**MONTGOMERY COUNTY HISTORIC PRESERVATION COMMISSION**  
**STAFF REPORT**

| <b>Address:</b>    | 10012 Menlo Ave., Silver Spring  | <b>Meeting Date:</b>  | 12/4/2024     |
| <b>Proposal:</b>   | Partial Demolition, Two Story Addition, Hardscape Alteration, and Tree Removal |                       |               |

Staff recommends the HPC **approve with one condition** the HAWP application:

*Figure 3: Updated streetscape study.*

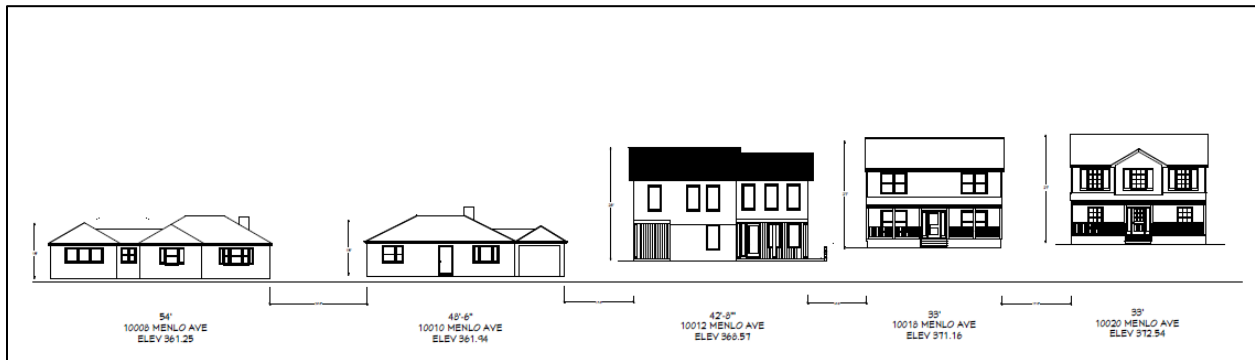
Staff concurs with the finding of the majority of the Commissioners at the October 9<sup>th</sup> Preliminary Consultation, finding the massing of the proposed house with its relatively simple form and two side gables is appropriate for the variety of architectural styles found throughout the Capitol View Historic District. At the Preliminary Consultation, the applicant presented a streetscape study with an inconsistent scale that did not accurately represent the distance between the houses along Menlo Ave. *Fig. 3*, below, shows the revised streetscape study showing the change in elevation and the distance between the houses. Staff finds that while the proposed taller house will have a visual impact on the one-story ranch house to the south, it will not overwhelm the size and scale of the houses on the block or the surrounding district and Staff recommends the HPC approve the revised house massing and design under 24A-8(b)(2) and (d) and *Standards 2, 9, and 10*.

PROPOSED SITE PLAN  
SEPTEMBER 2024  
SCALE AS NOTED

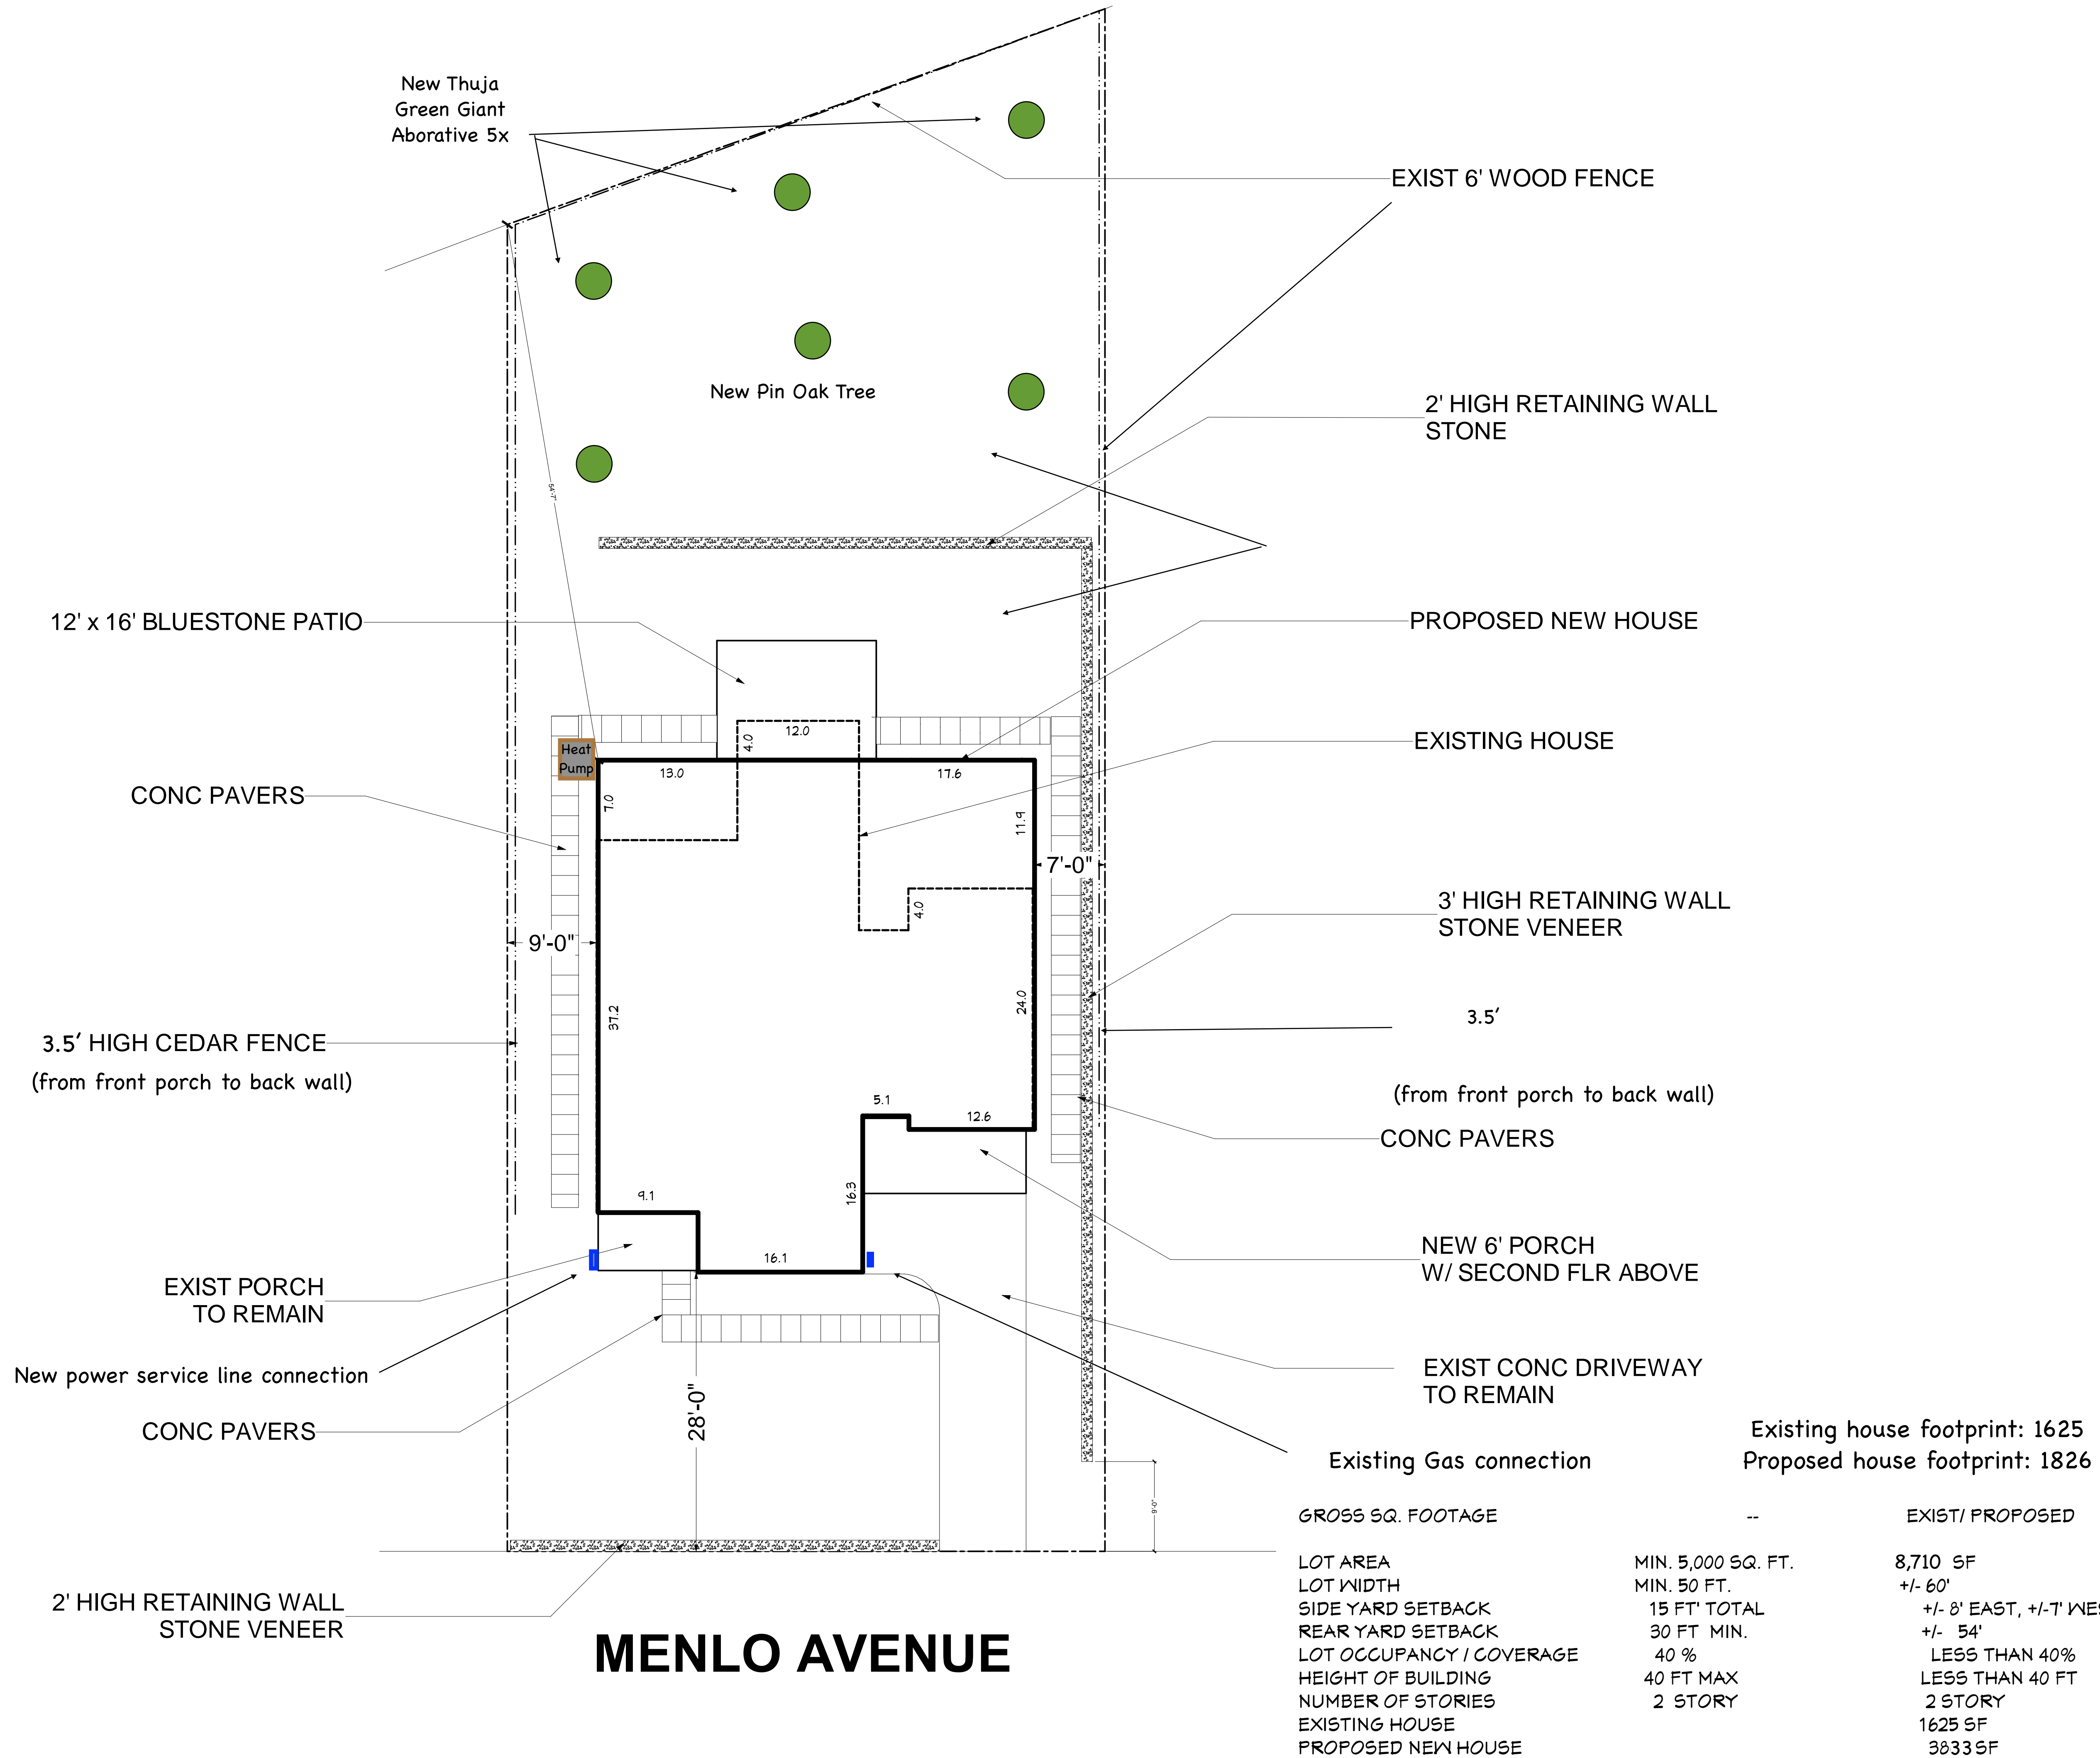
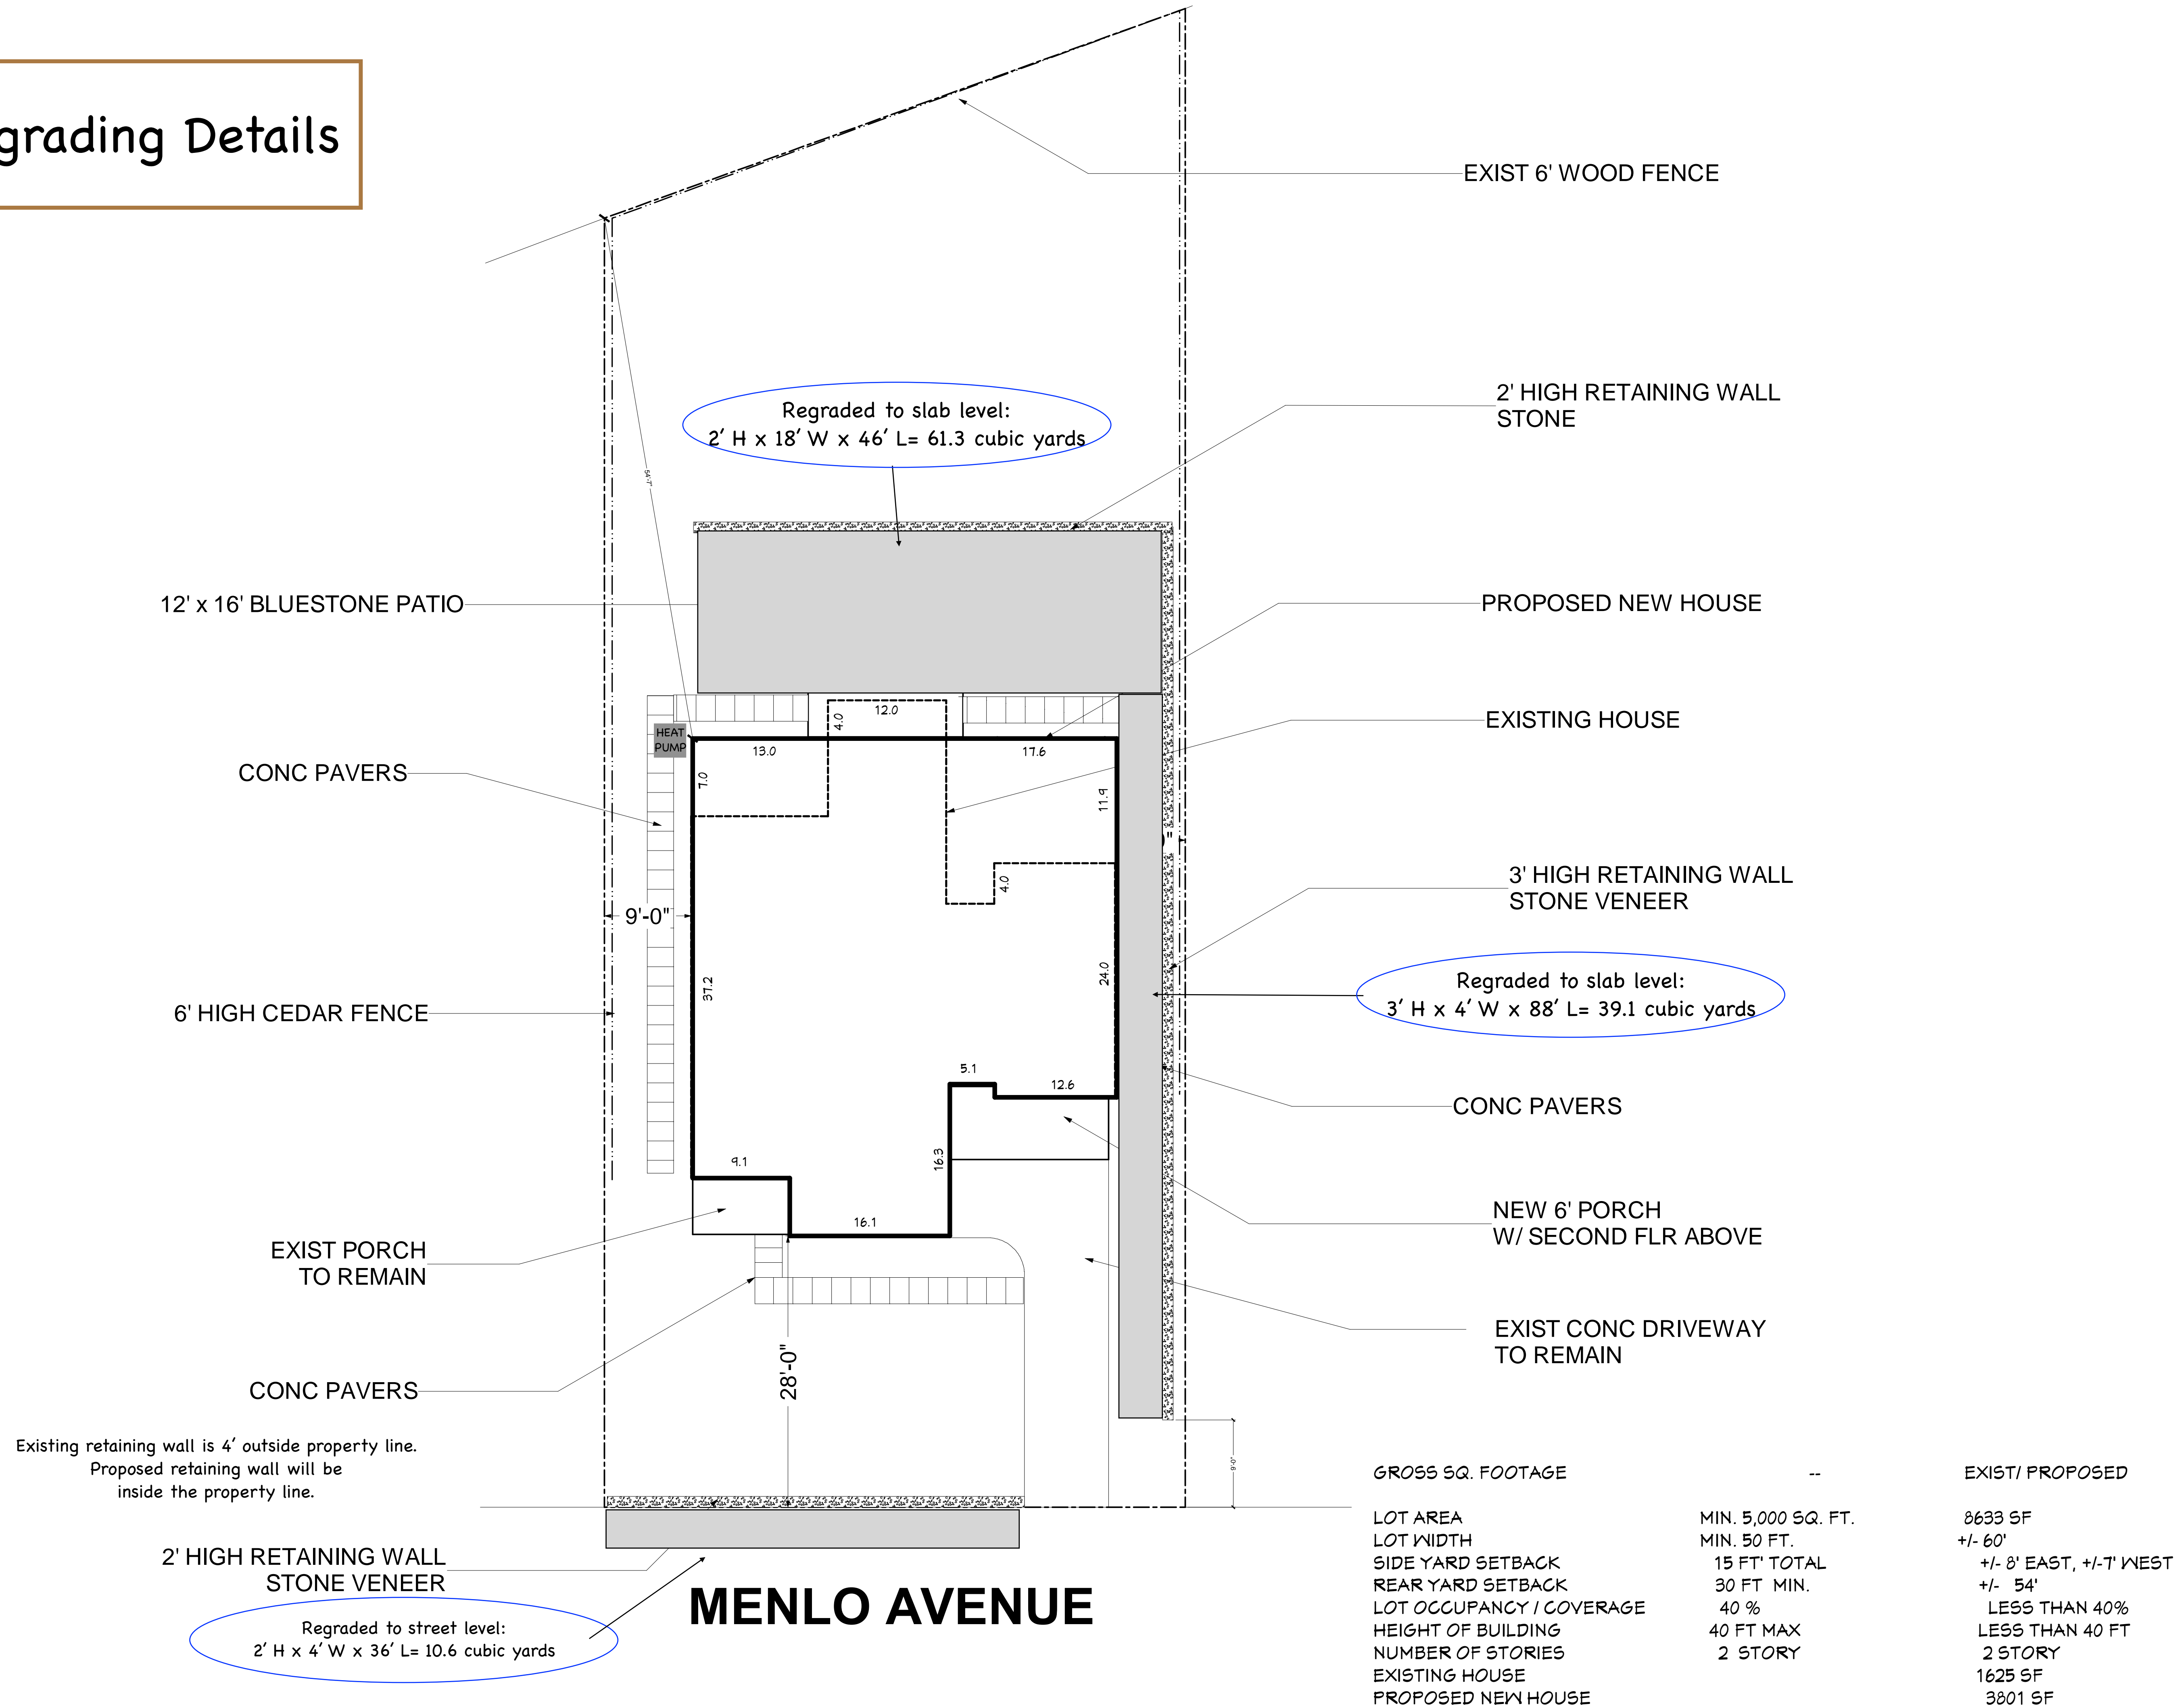
Staff finds that revisions are warranted to the proposed fencing. On the right side of the house, the applicant proposes to install a 3' (three-foot tall) retaining wall, as discussed above. Immediately adjacent to that retaining wall, the applicant proposes to install a 4' (four-foot tall) wood picket fence. The combination of the retaining wall and the fence, even though it has an open picket design creates a 7' (seven-foot tall) wall up to the front wall plane of the house. Staff finds this will negatively impact the open character of the district and Staff recommends the HPC add a condition to the approval of this HAWP that eliminates the proposed picket fence forward of the house's rear wall plane. This would still allow for a 3' (three-foot tall) barrier between the subject property and its neighbor to the north. Further, the applicant proposed to install a 6' (six-foot-tall) privacy fence along the south property line. The HPC's typical condition for fences in the Capitol View Park Historic District is that they are limited to no taller than 48" (forty-eight inches tall) and have an open picket design. This height and design restriction

helps to reinforce the sense of openness that is characteristic of the district. Staff recommends the HPC add a condition to the approval of this HAWP that any fence forward of the rear wall plane on the south property line be limited to 48" (forty-eight inches tall) and has an open picket design. The fence to the rear of the rear wall plane may be 6' (six feet tall) with a solid appearance. With the identified conditions, Staff recommends the HPC approve the proposed fences under 24A-8(b)(2) and (d) and *Standard 2*.

1. The 4' (four-foot tall) fence along the north property line cannot extend forward of the rear wall plane. The fence on the south property line, forward of the rear wall plane, cannot be taller than 48" (forty-eight inches tall) and must have an open picket design. Final approval authority to verify that this condition has been satisfied is delegated to Staff;

**STREETSCAPE STUDY ALONG MENLO AVE**

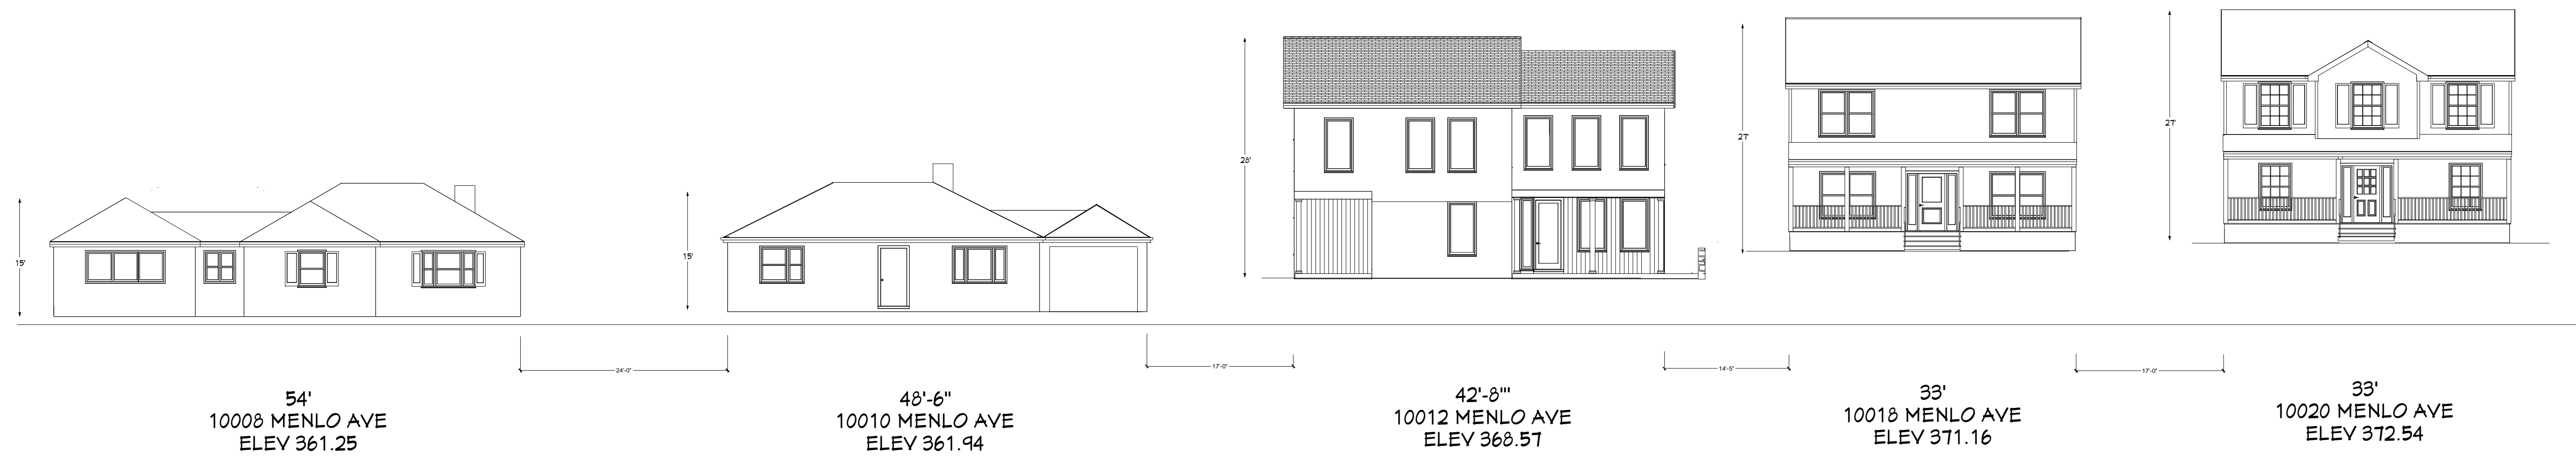
subject property both added a second story: the house at 10018 Menlo Ave. added a second story in 2013<sup>3</sup> and the house at 10020 Menlo Ave. added a second story in 2000.<sup>4</sup> Staff finds the proposed second story will not impact any historic fabric and that the height of the new house at 28' (twenty-eight feet) will not overwhelm the character of the block.
